**COMPRESSOR REMANUFACTURING MANUAL  
VOLUME 1**

**SECTION 5  
SUB SECTION  
10 August 1998**

**CARRIER BULLETINS**

**Carrier 06D & 05K Oil Pressure Regulating Devices**

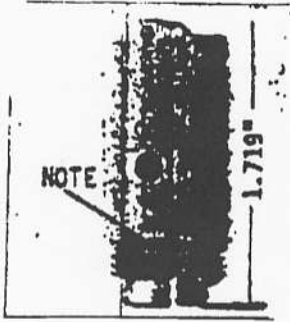
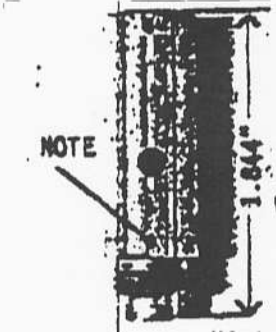
Part Number	Application
 <p>6D23-522 (obs version)</p> <p>1.719"</p>	<p><b><u>MUST BE USED WITH ALL 13 &amp; 16 CFM MODELS WHEN USING THE OLD STYLE 4 CYLINDER CRANKCASE</u></b></p> <p>Acceptable as an alternate to current 6D23-522 part (Note dimensions)</p>
 <p>6D23 - 522 (current))</p> <p>1.844"</p>	<p>REFRIGERATION.MEDIUM TEMP, &amp; COMPOUND COOLING MODELS "D" MODELS (NO ALTERNATES) EXCEPTION - SEE OLD STYLE 6D23-522 (ABOVE)</p> <p>DESIRED ON A/C MODELS</p>
 <p>05KA404-044</p> <p>1.227"</p>	<p>USED ON ALL 05K COMPRESSORS</p>
 <p>06DA407 - 432</p> <p>.855"</p>	<p>AIR CONDITIONING MODEL "D" COMPRESSORS AS AN ALTERNATE TO 6D23 - 522 RELIEF VALVE</p> <p>ALSO 06DM 8089G (SERVICE COMP SPECIAL)</p>
 <p>06DA 508 022</p> <p>.550"</p>	<p>USED ON ALL 06DR 241 MODELS</p>
